**CITY OF ESCONDIDO**  
**Planning Commission**

Agenda Item No.: G.1  
Date: January 14, 2003

**CASE NUMBER:** Tract 799, 2001-36-SOI, 97-20-PZ/SP/GE, 2002-07-AN, ER 97-25, ER 2001-30 Valley View Estates

**PROPOSED PROJECT:**

**STREET INCLINATION STUDY**

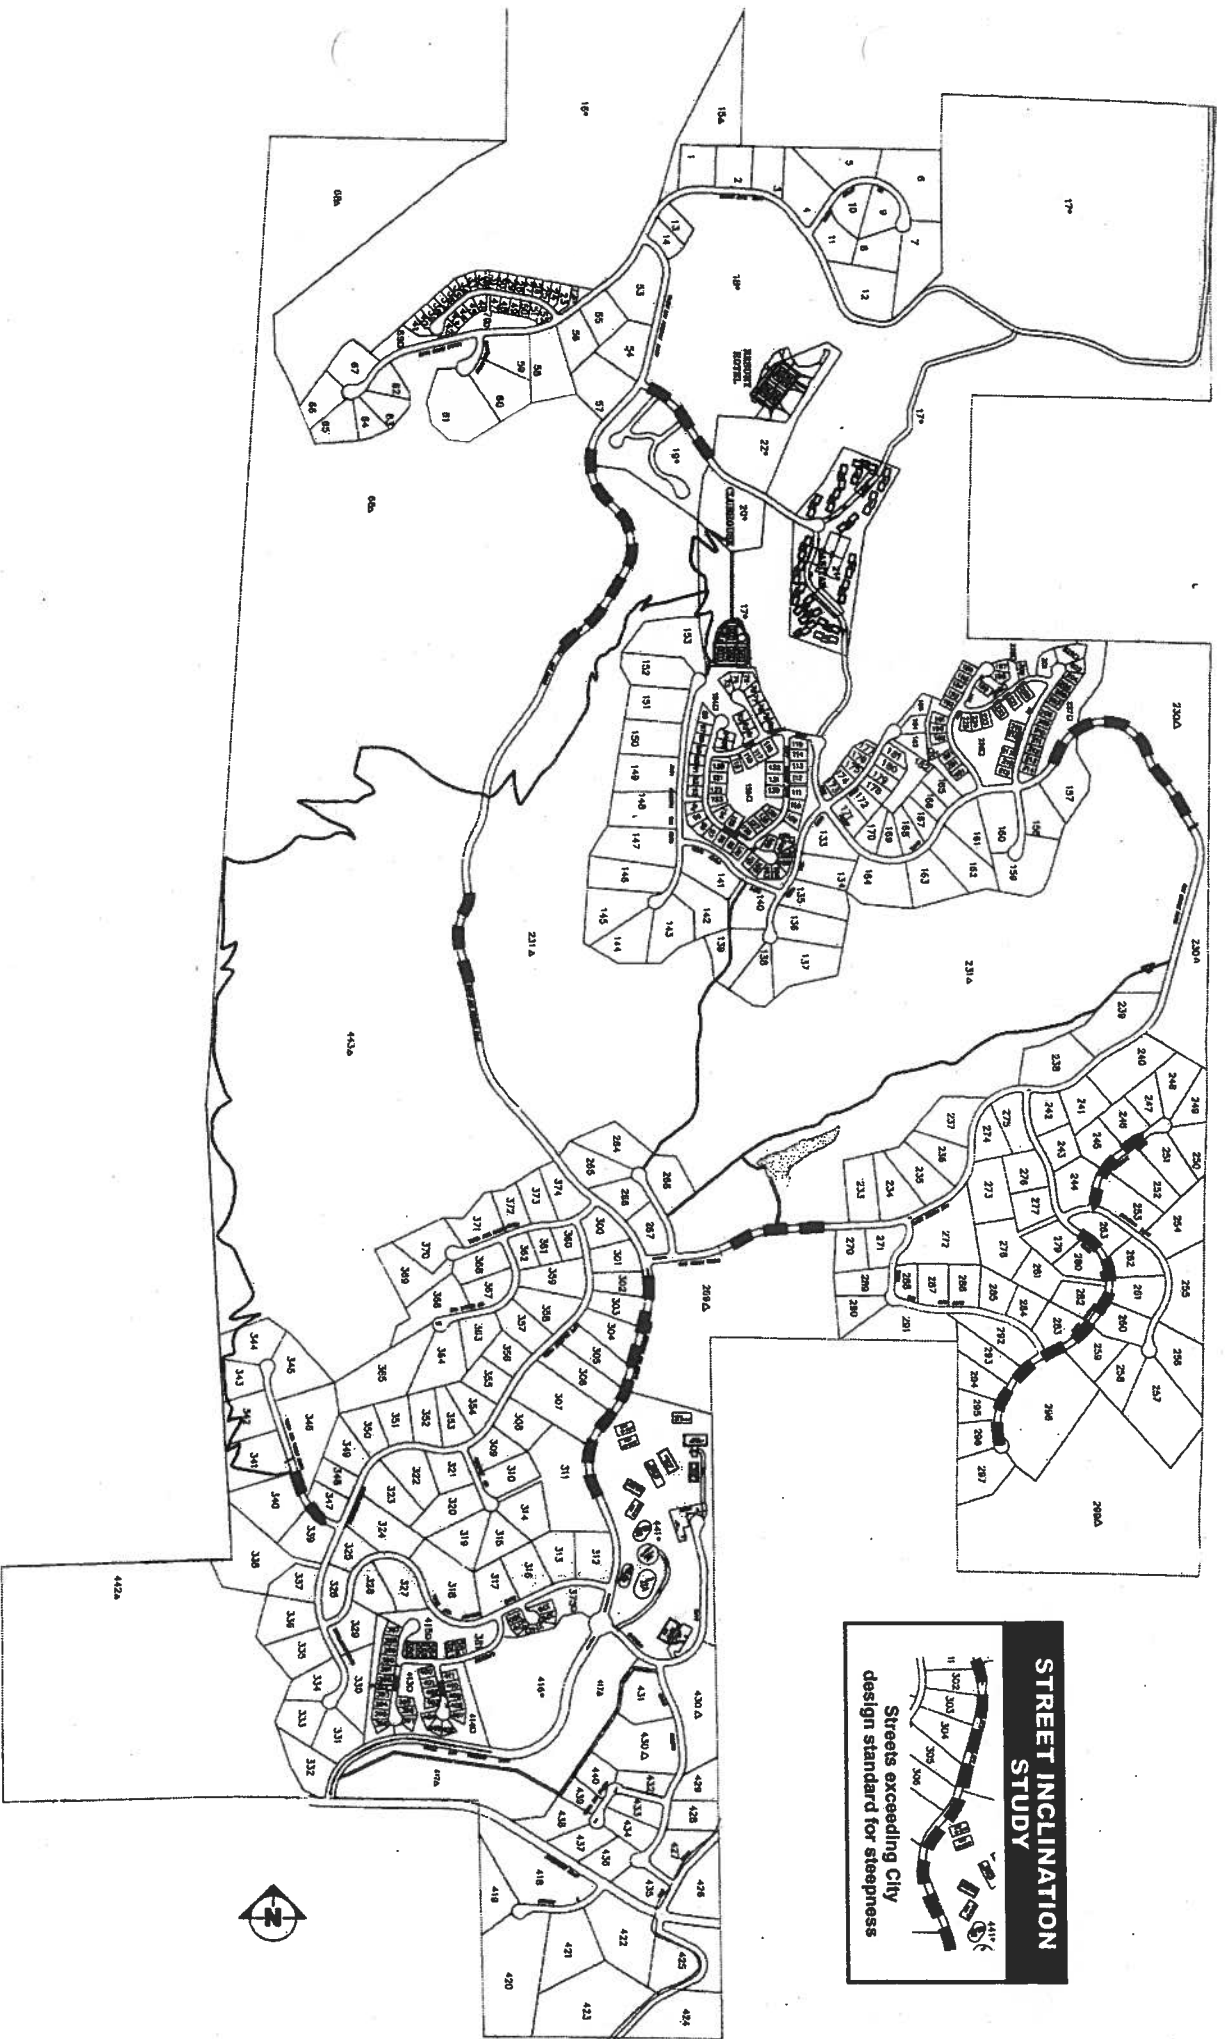
City Residential Street standards call for a minimum 36-foot wide paved surface within a 56-foot wide right of way, a maximum 20% inclination, minimum 425-foot radius curves with at least 90-foot separations between curves. This standard can accommodate up to 25 mile per hour vehicle speeds. The Specific Plan requests Residential streets with a minimum 28-foot wide paved surface in a 32 foot-wide right of way area. All proposed residential streets are 20% inclination or less. However, the Specific Plan proposes residential streets with minimum 66-foot radius curves with no separation between curves. The proposed standard would reduce vehicle speeds in certain areas to 11 miles per hour. City standards also limit cul-de-sac lengths to 800 feet. The Specific Plan requests cul-de-sacs up to 2,200 feet long.

Streets exceeding City design standard for steepness
